*Presentation to U.S. EPA Region 5 by the
Trustees of the Environmental Conservation
and Chemical Corporation Site Trust Fund*

THE RRA AT THE ENVIRO-CHEM SITE ZIONSVILLE, INDIANA

14 August 1997

REVISION 2

FIGURE 2-2
SITE CROSS SECTIONS
ENVIRO - CHEM SITE
ZIONSVILLE, INDIANA

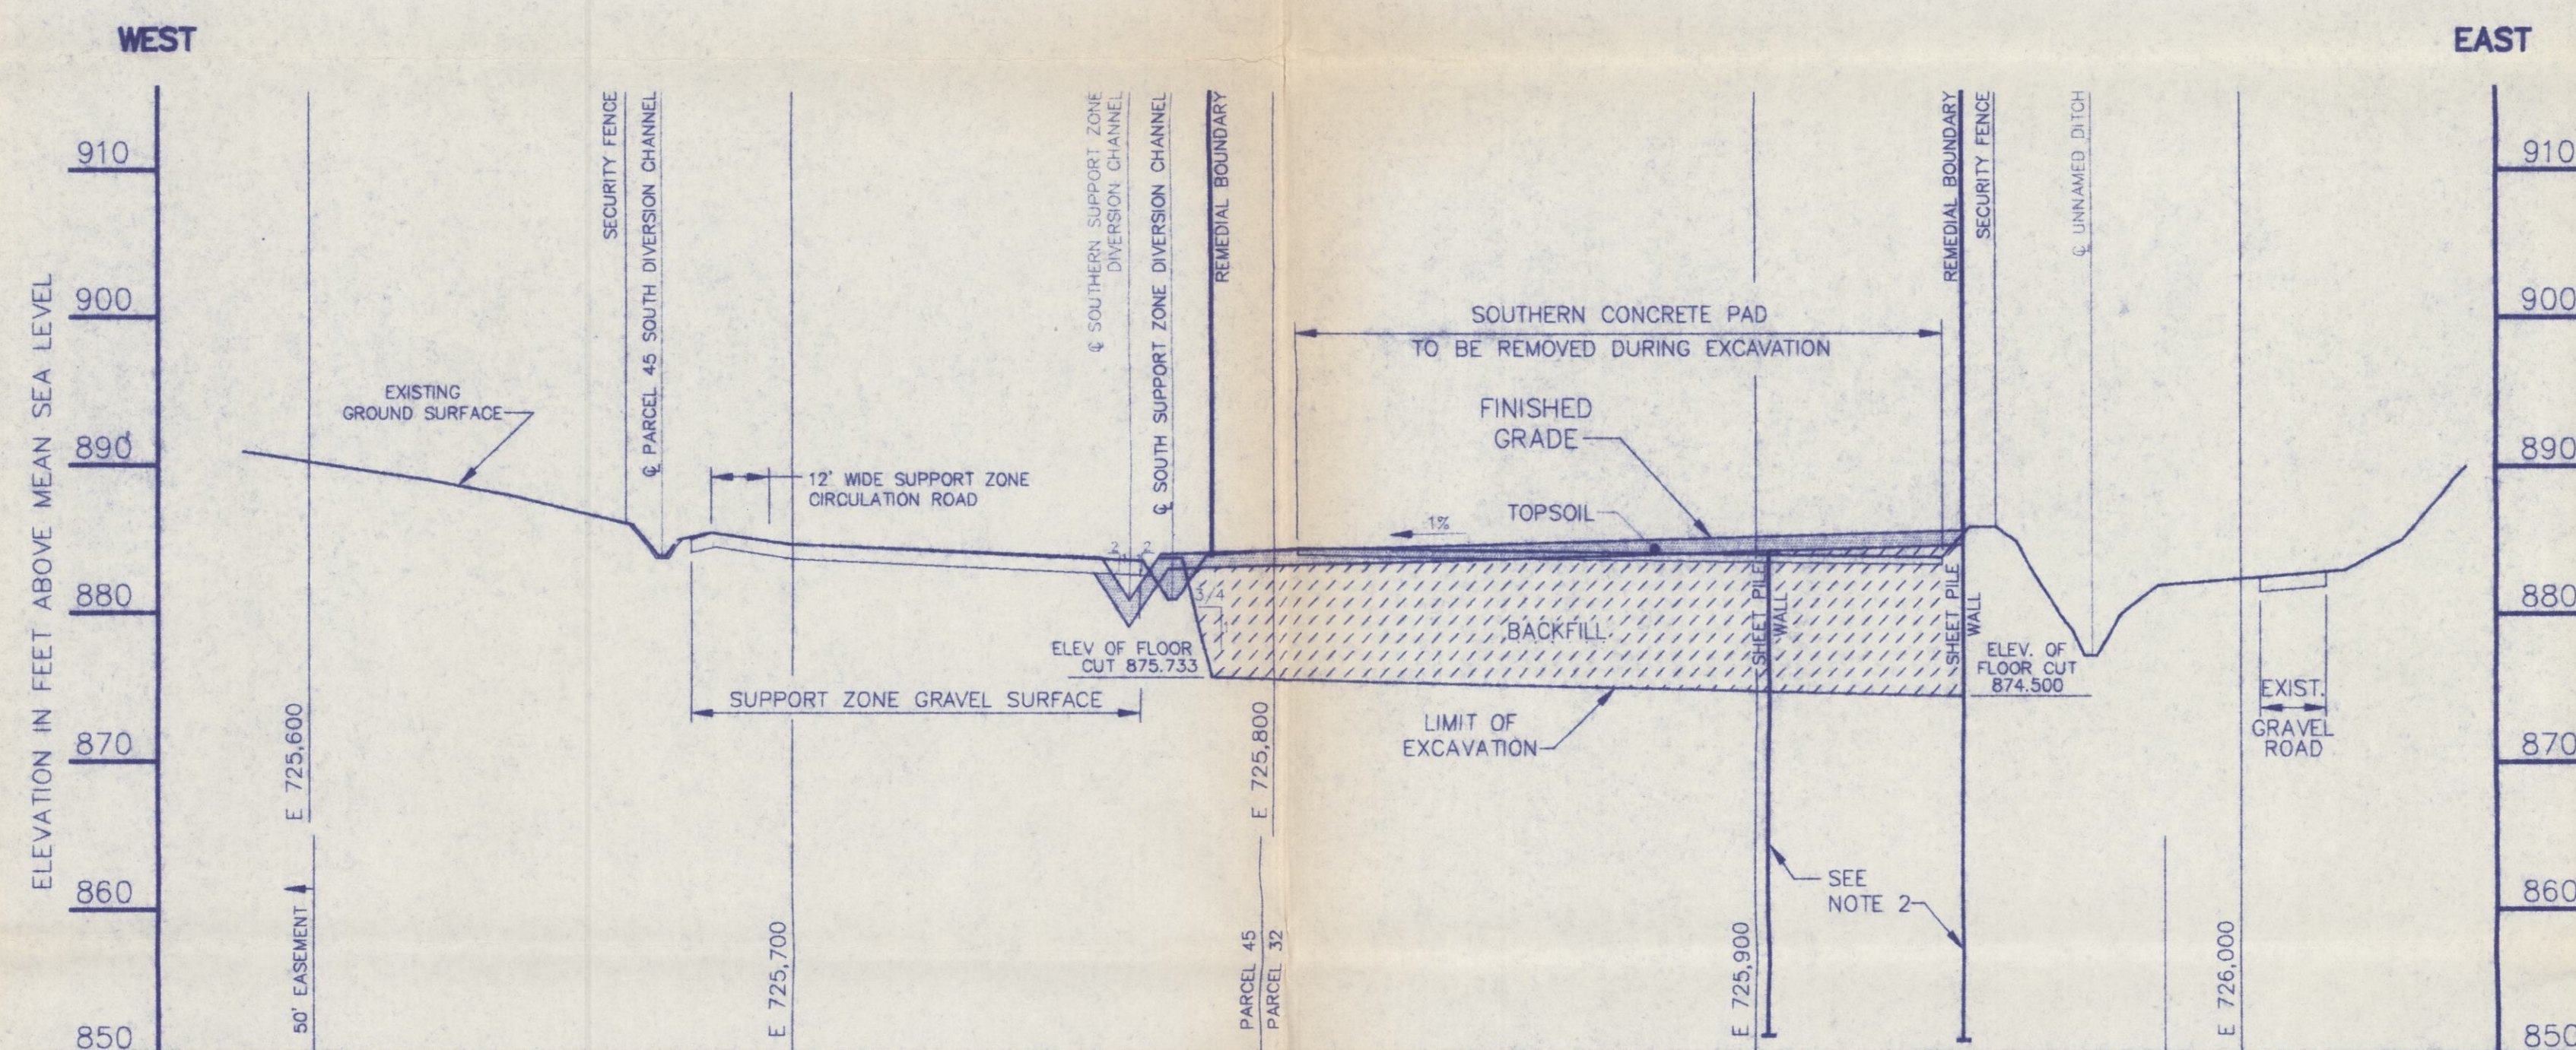
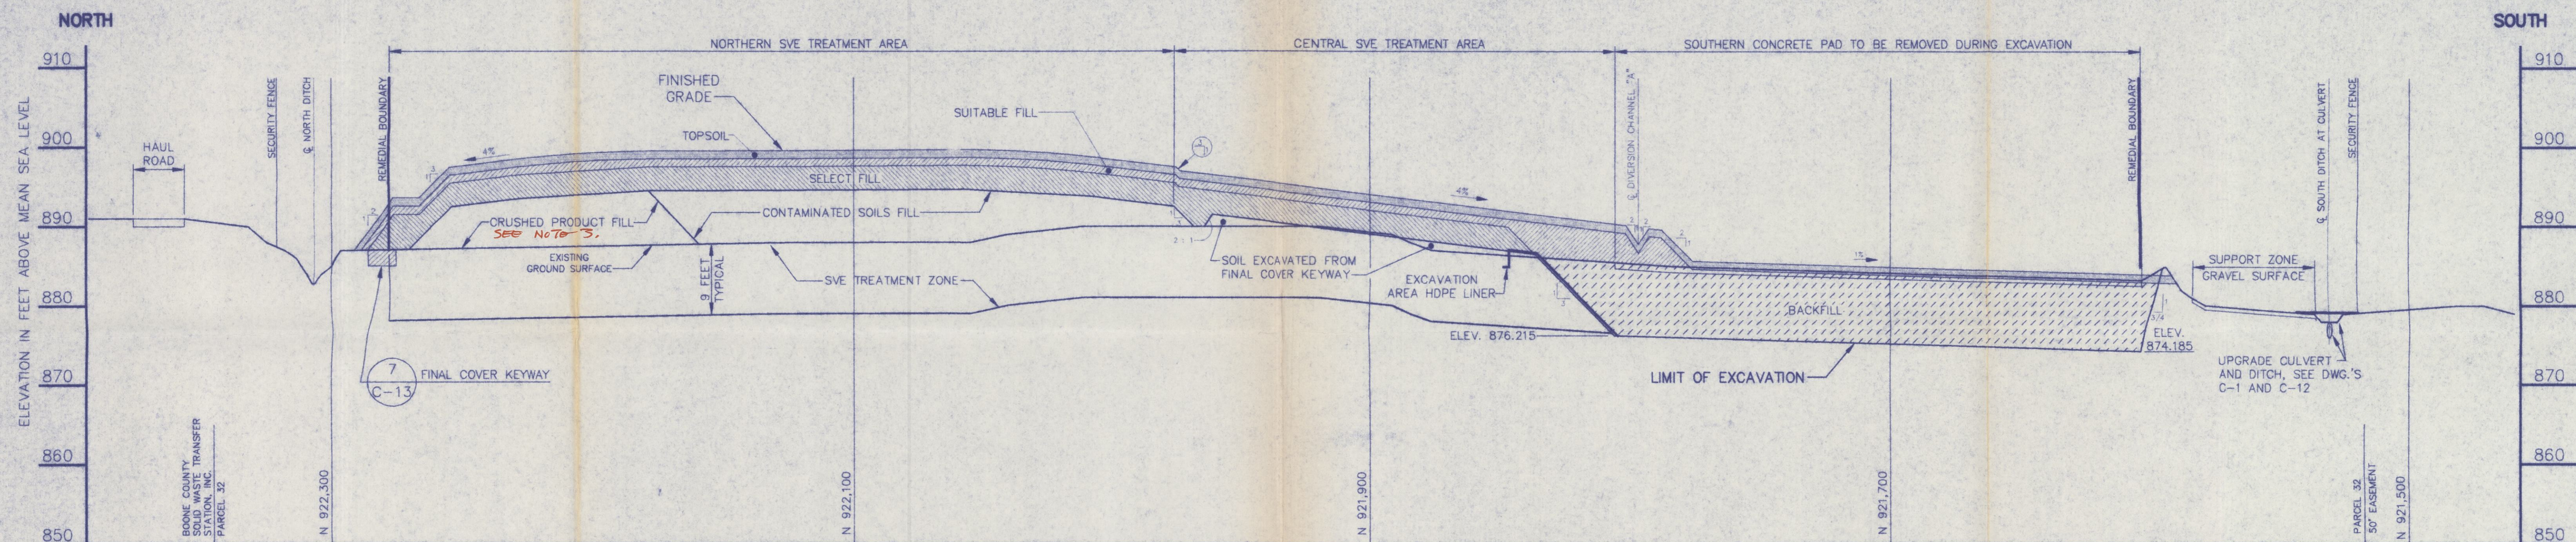
1. Use of the crushed concrete pad and recovered sub-base materials to back-fill trenches for the SVE system vacuum vents. Approximately 900 cubic yards of crushed materials (i.e., smaller than three inches in diameter) would be utilized to backfill the SVE system trenches with the remainder being deposited in the segregated treatment zone identified in Revised Exhibit A (Revision 1). This modification would result in this material now receiving the highest degree of treatment possible, because it is the closest contact material to the SVE system vents. In addition, the overall volume of material to undergo treatment would be decreased by approximately 900 cubic yards, as a direct result of the aggregate fill that would not now be required around the SVE system vents. This lesser volume would also decrease the overall size of the temporary and final caps for this area. The action will require no change in the text of Revised Exhibit A (Revision 1), but will require revision to drawing 2-2.

3. THE CRUSHED PRODUCT AREA SHOWN IS APPROXIMATE IN DIMENSION. ALL CRUSHED CONCRETE AND SUB-BASE MATERIALS NOT USED IN SVE TRENCHES WILL BE PLACED IN THIS AREA.

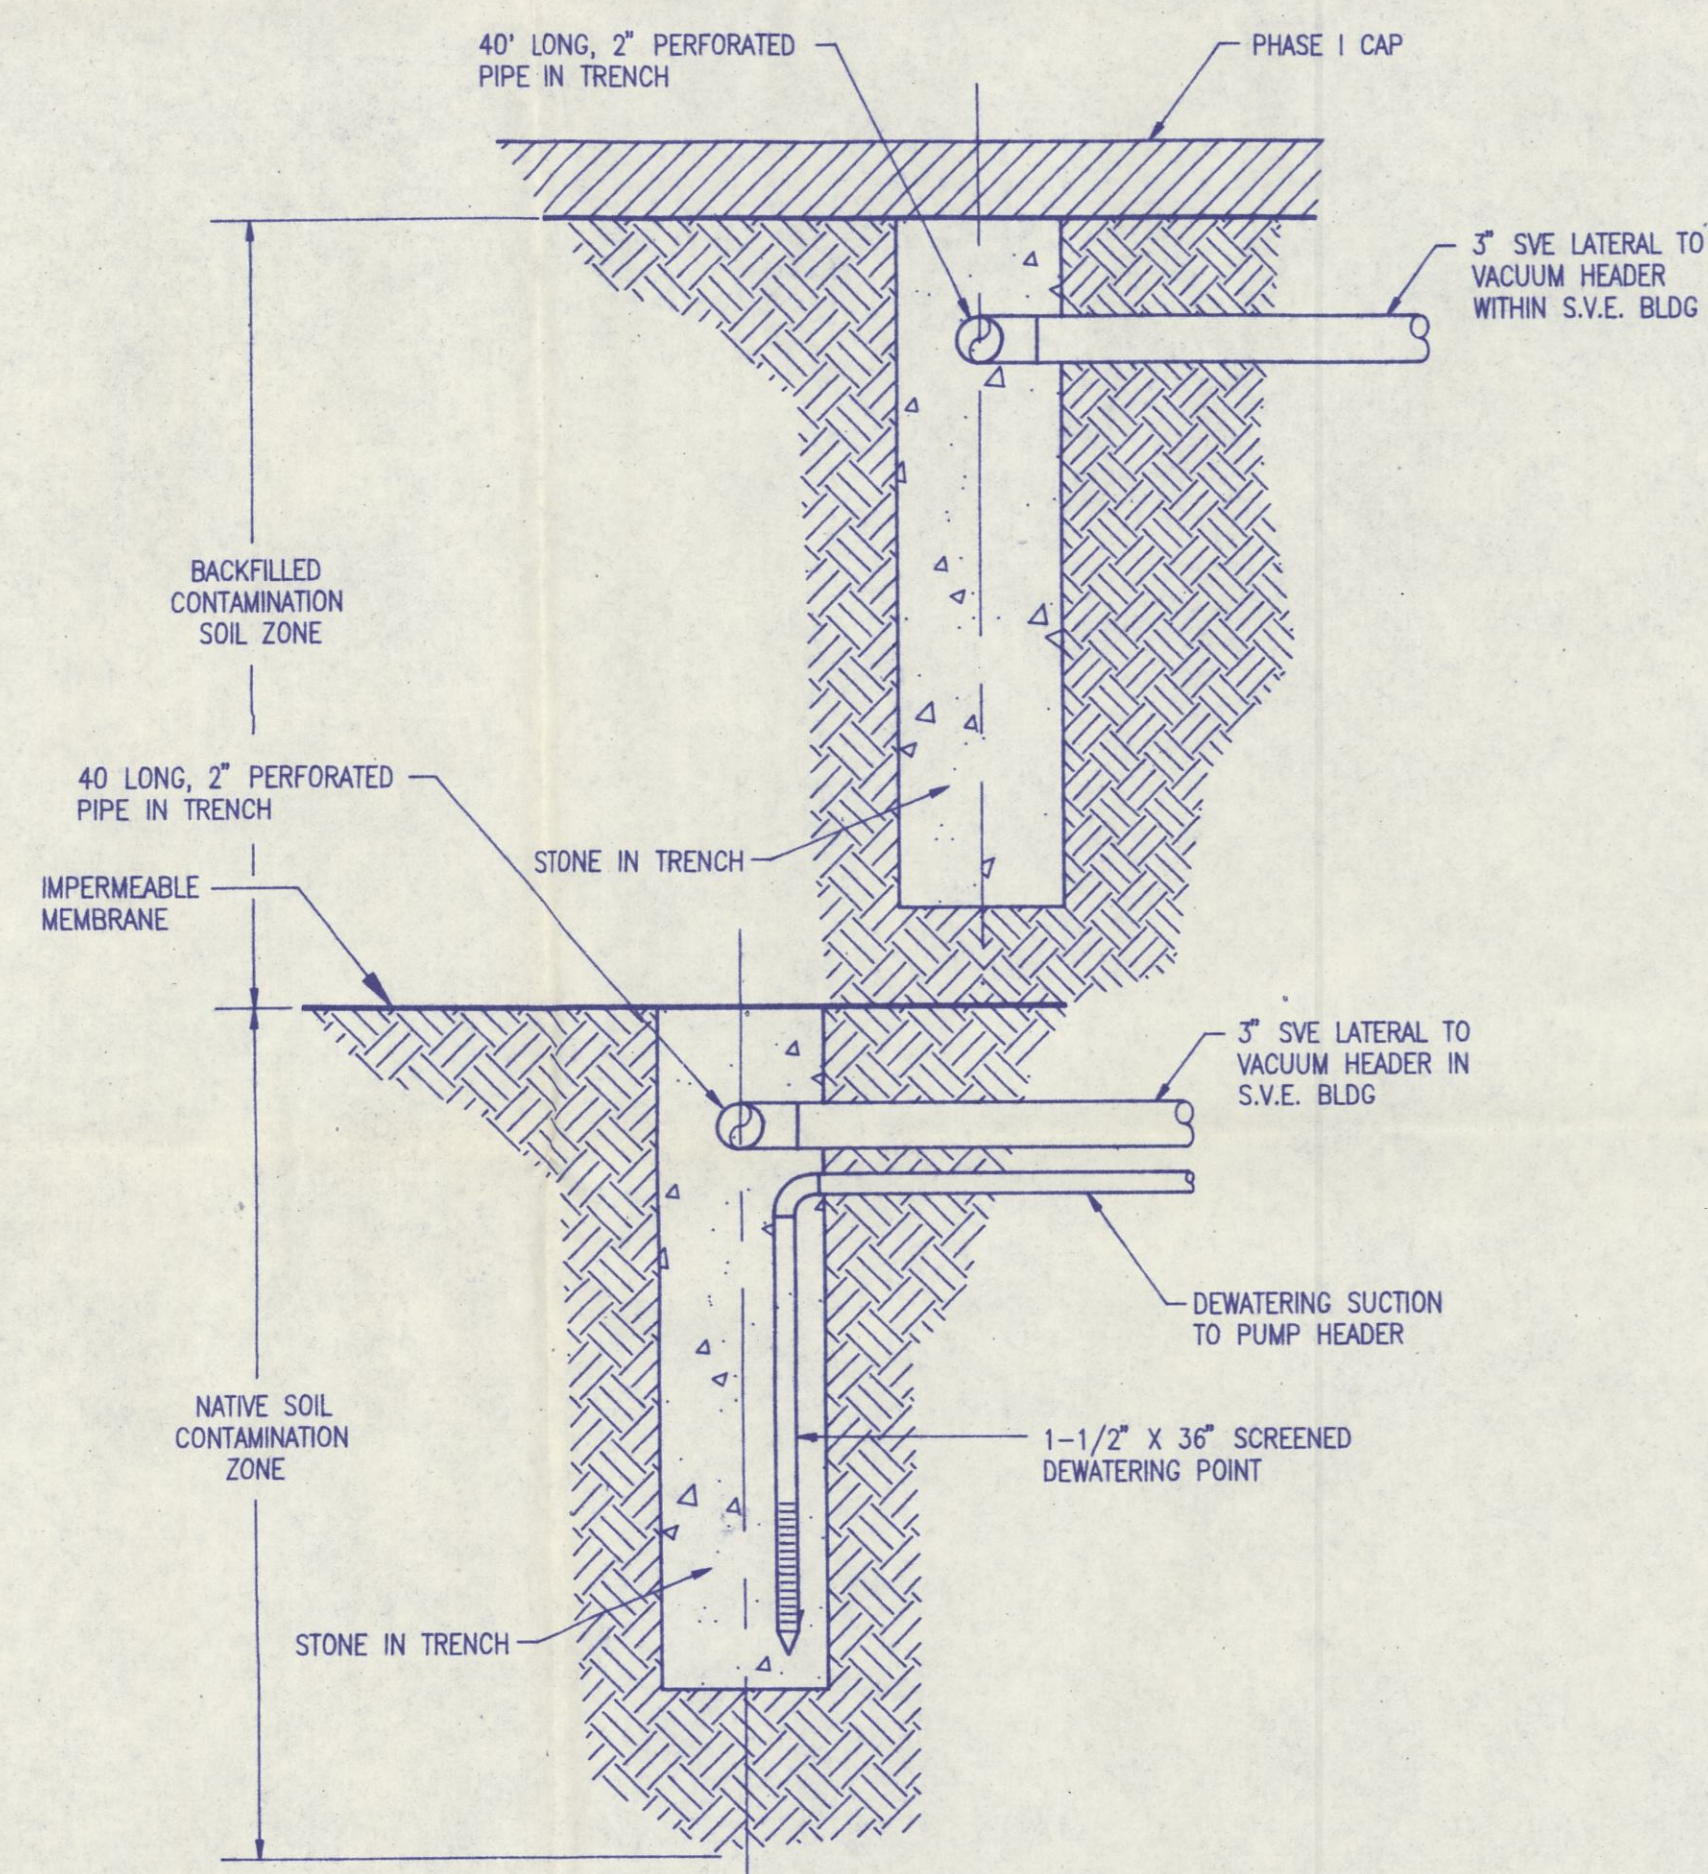
- a. Fifty-four SVE trenches will be installed within the native soils of the Northern and Central SVE treatment areas, see VERSAR drawing, sheet 1. The zone of influence for the treatment system in the native soil is greater than 17 feet below grade (i.e., vent pipes installation at two feet plus a radius of influence for the each vent of more than 15 feet for a total zone of influence of 17 feet), which is more than the nine foot effective minimum depth for treatment design basis specified in Revised Exhibit A (Revision 1). Each trench will be excavated to a depth of eight feet below grade and then
